CITY OF ALBUQUERQUE

**RE: 2440 Louisiana Lots
Conceptual Grading and Drainage Plan
Submittal Date 5-17-2016 (File: H19D084)**

2440 LOUISIANA LOTS
Albuquerque, New Mexico
SITE PLAN FOR SUBDIVISION
DRB SUBMITTAL

CONCEPTUAL
GRADING
PLAN

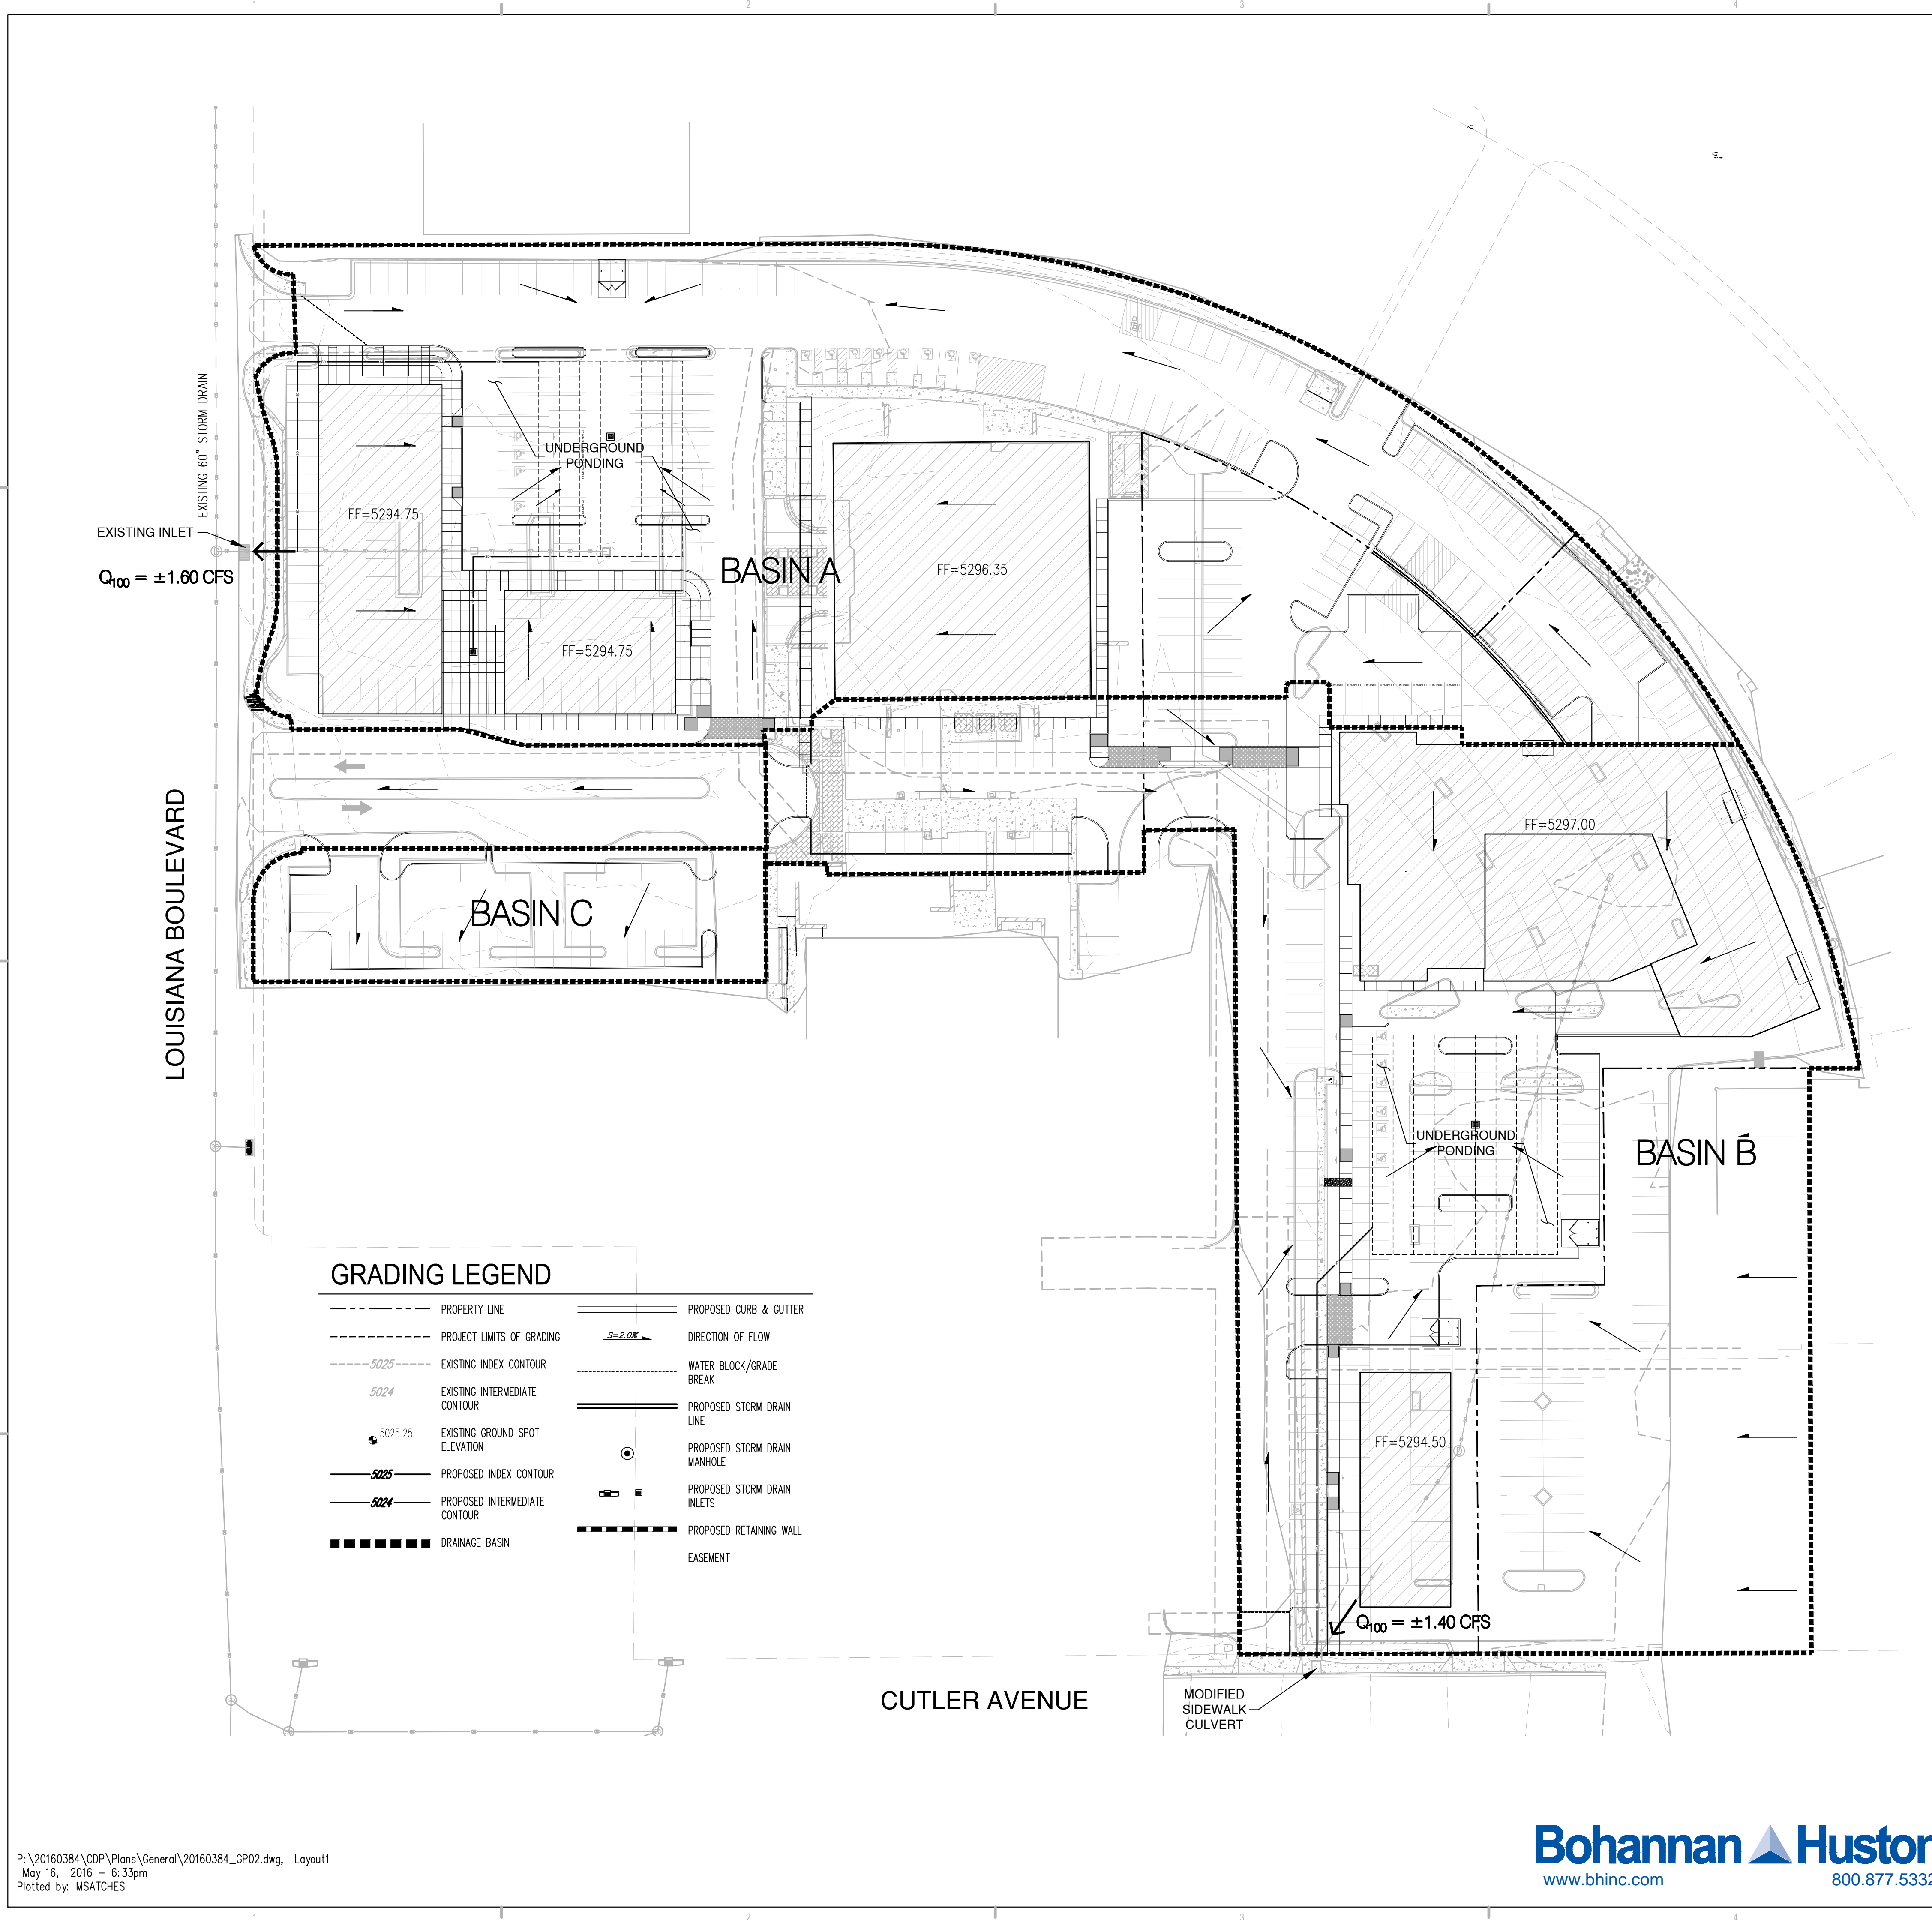
Based upon the information provided in your submittal received 5-17-16, and as discussed at a previous DRB Hearing (6-15-2016) the above referenced Grading and Drainage Plan is approved for Site Plan for Subdivision (#1010042).

Please make sure to be aware that if the final grading and drainage plan needs cross-lot drainage easements they will be required for final sign off.
